**Re: PUC (Transmission) LP by its general partner PUC (Transmission) GP Inc.
("PUCT")
Proceeding No. EB-2023-0360 ("Proceeding")
Post-Approval Modifications**

We are legal counsel to PUCT. On August 27, 2024, the Ontario Energy Board (the "**OEB**" or "**Board**") issued its Decision and Order in the above-noted Proceeding, granting PUCT leave to construct certain transmission facilities near Sault Ste Marie, Ontario ("**Decision**"). We write to advise of post-approval modifications to the project, as well as to clarify the applicable deadline for seeking OEB approval of performance standards under section 4.5 of the Transmission System Code ("**TSC**") (the "**Performance Standards**"). The following matters are addressed:

Figure 1: Approved plan of subdivision – Chippewa Street Development

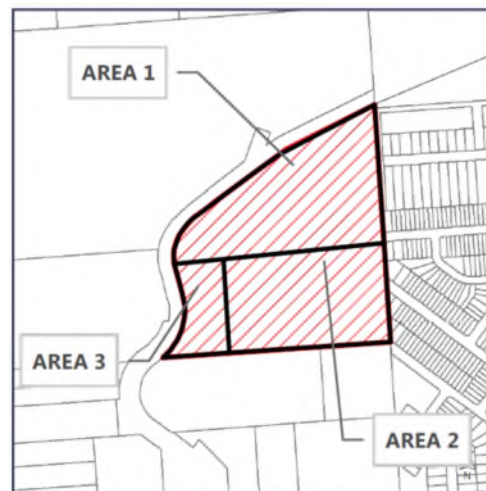
Following the OEB’s approval of the transmission line route in its Decision, further engagement with landowners and developers in the Chippewa Street Development area resulted in requests for minor route deviations away from these properties during the refinement of design and construction plans, resulting in two proposed route deviations near areas 1 and 3 in the figure above.

PUC TRANSMISSION 230 kV FACILITIES
230 kV AREA PROTECTION AND CONTROL
SINGLE LINE DIAGRAM

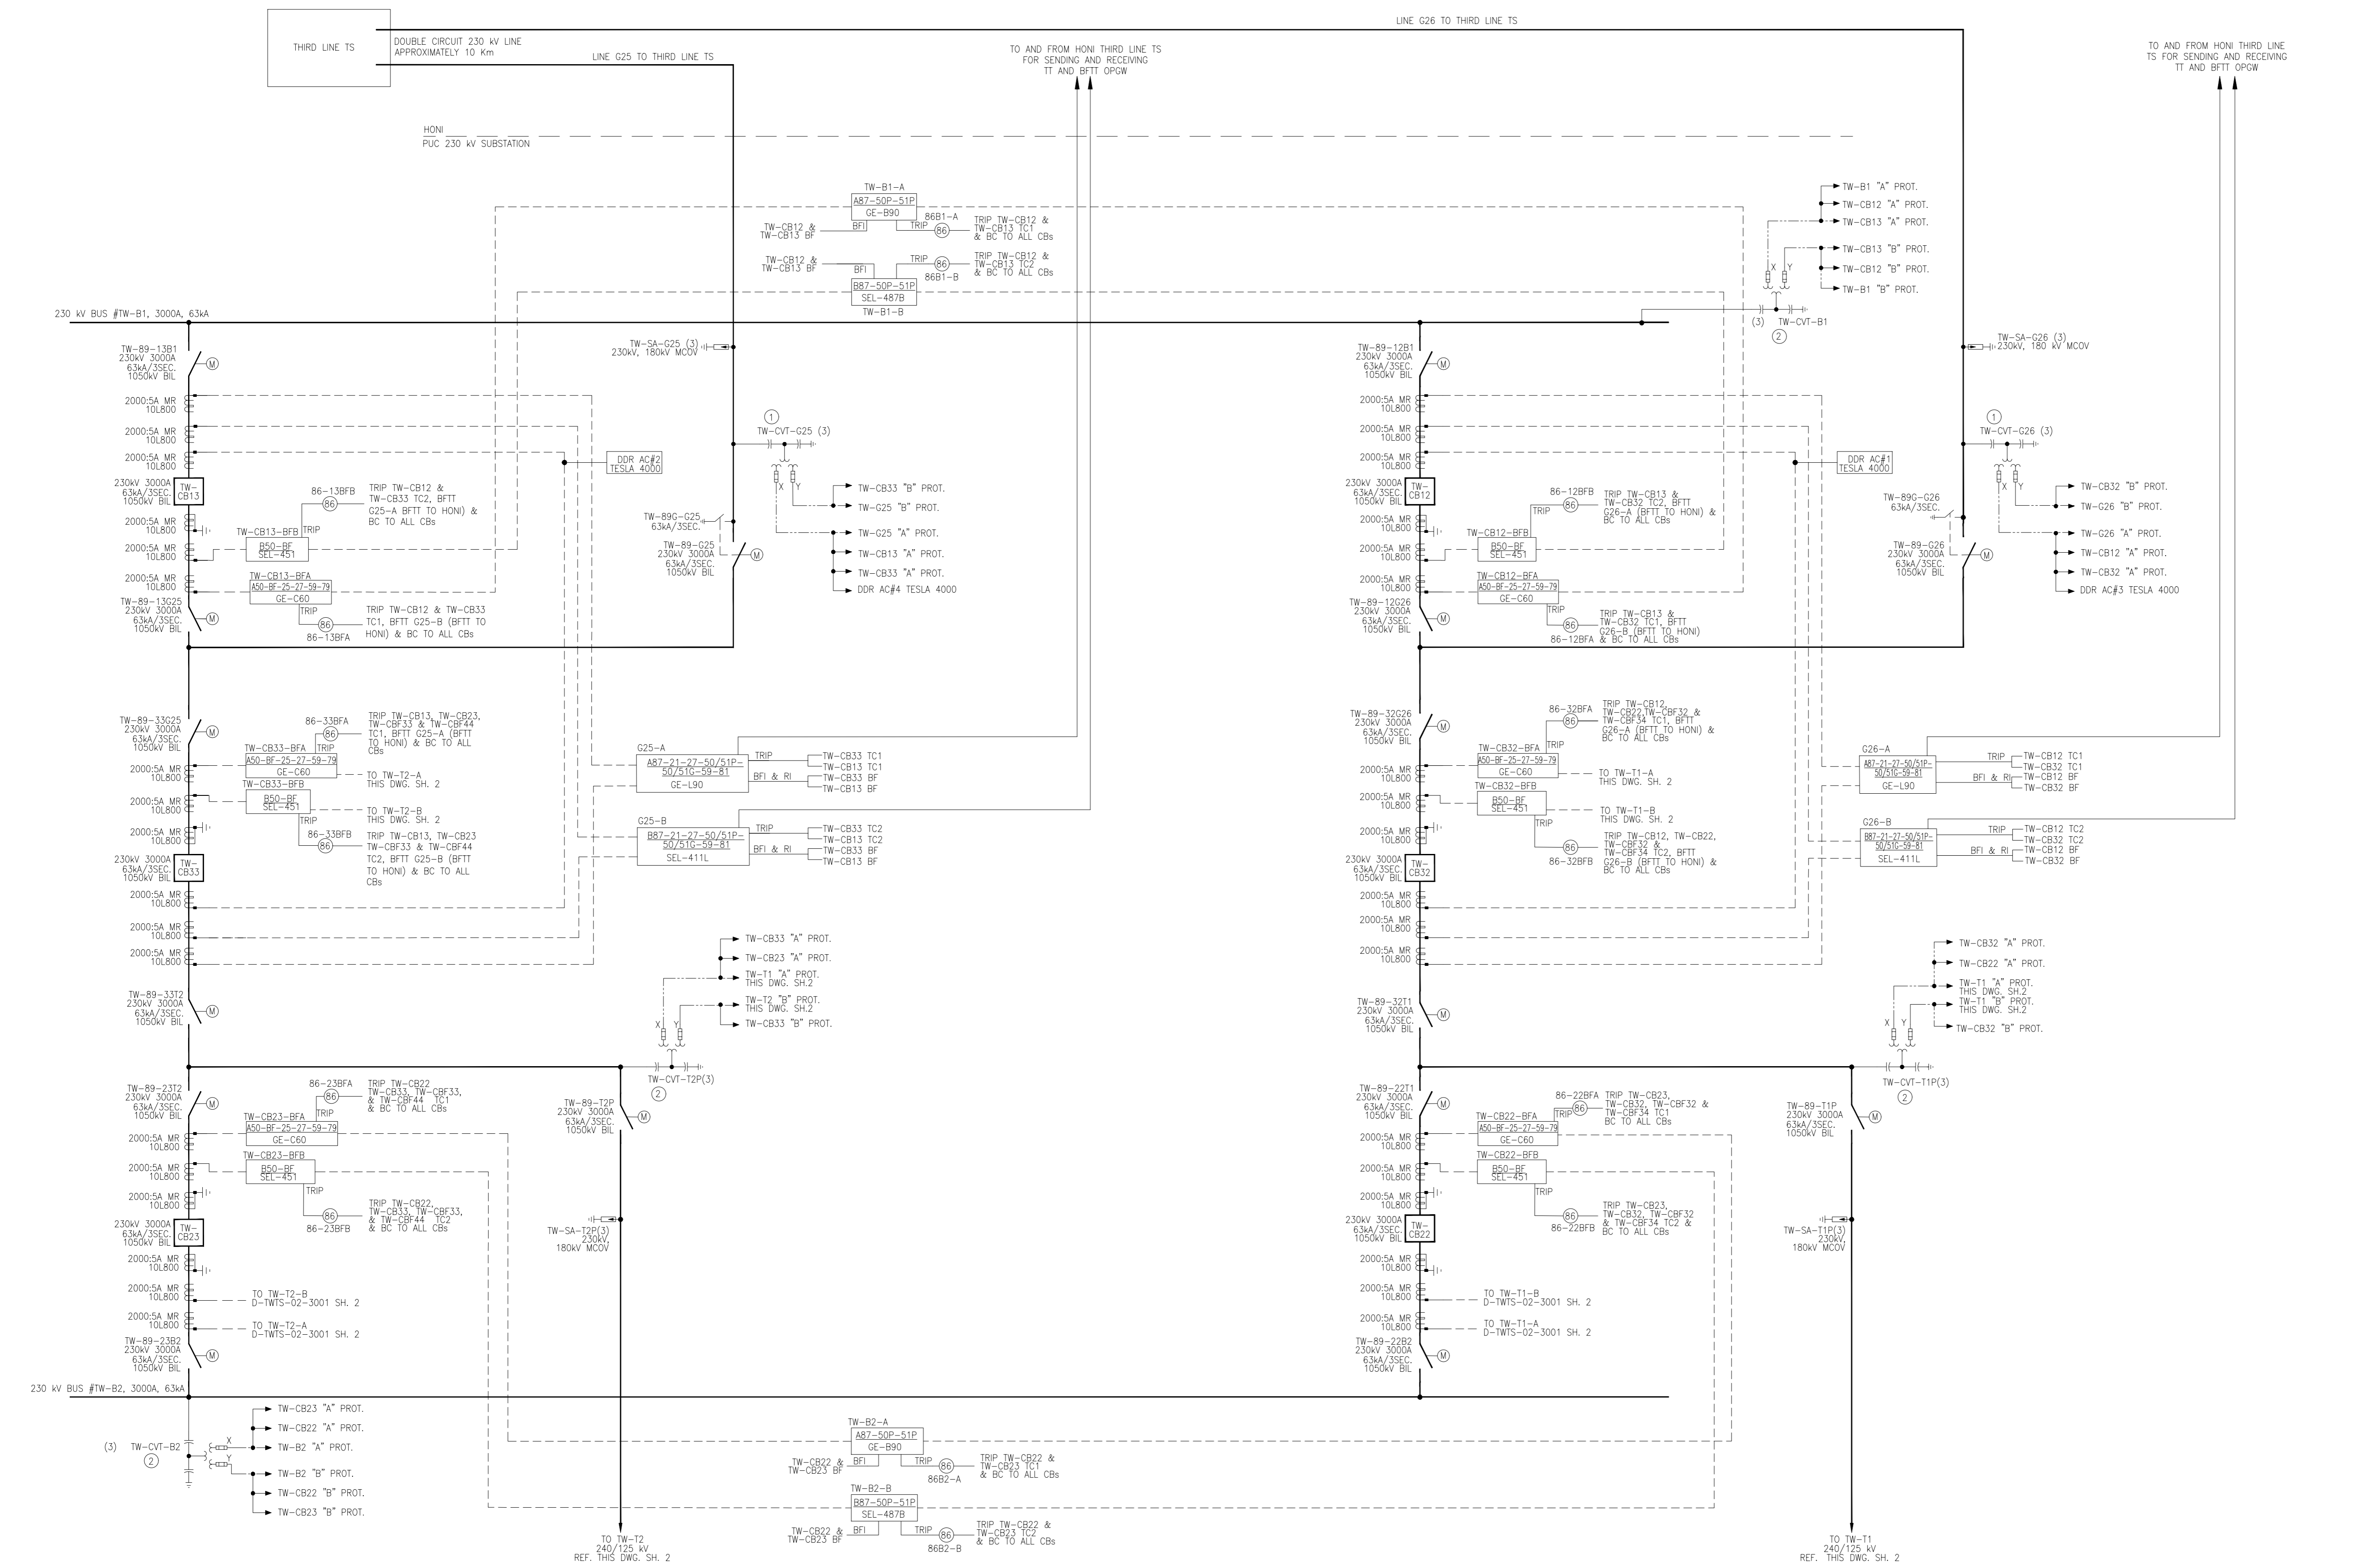
PUCT, in consultation with the IESO, Algoma Steel, and vendors, determined the solution was to install a STATCOM only, connected to the 115 kV buses and rated at +/- 140 MVar.

Attached as Appendix A are the updated single line diagrams to reflect the use of the 140 MVar STATCOM. This design enhancement will not have any impact on the physical footprint of the project. Given the STATCOM is part of the minimum connection requirement for the customer, this will not have any impact on network ratepayers. Further, the customer will not require a capital contribution because, as set out in the LTC, the net present value of the load is greater than the cost of the connection requirements.¹²

Appendix B

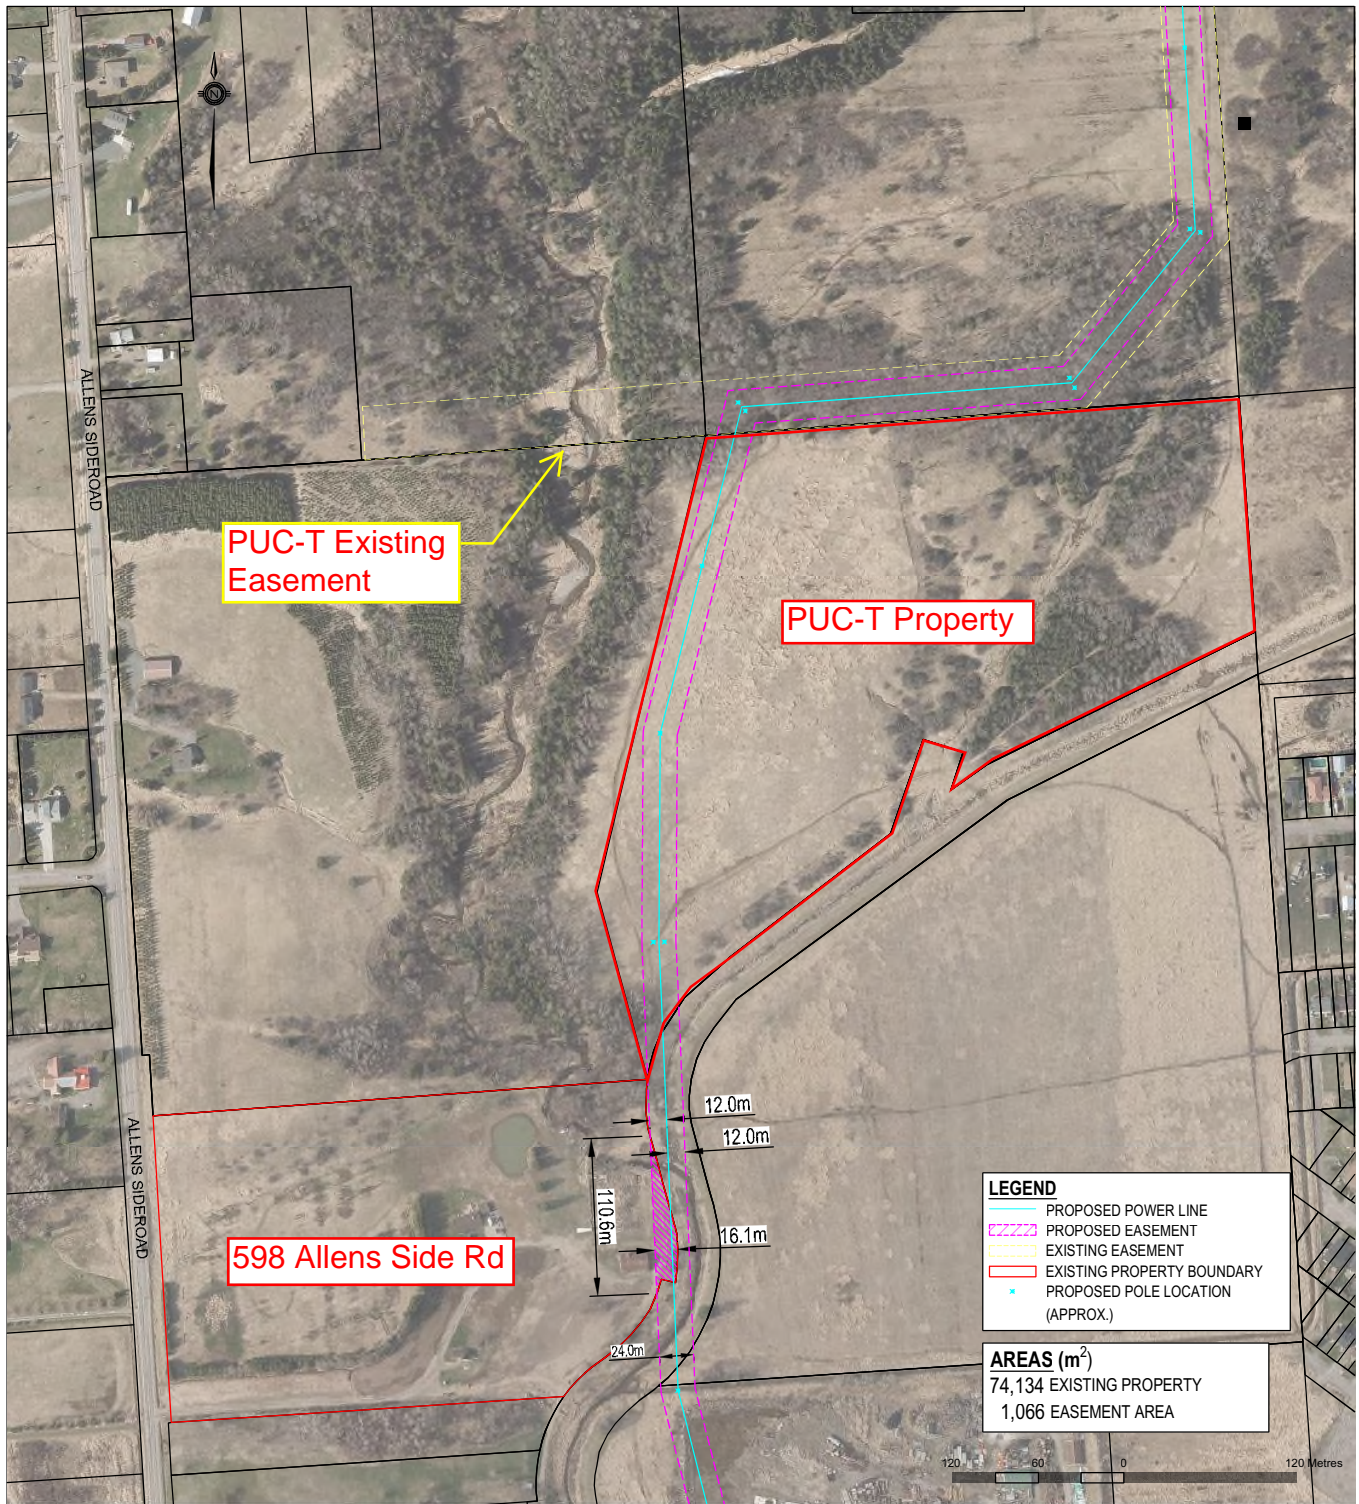
The developer in area 1 requested that the PUC Transmission Project be shifted further north from the alignment in the LTC Application, as shown in the diagram 2214-P001-S5 (copy attached as Appendix B).¹⁶ Enclosed as Appendix C is the minor route shift to the north to address the concerns raised by the developer to increase the distance between the PUC Transmission Project and the planned subdivision. The route deviation is located on an existing easement owned by PUCT (yellow dashed area in Appendix C) and on land owned by PUCT (area outlined in red in Appendix C). The number of poles required for the adjusted route remains unchanged.

The developer in area 3 requested that the PUC Transmission Project be shifted further west from the alignment in the LTC Application, as shown in the diagram 2214-P001-S5 (copy attached as Appendix
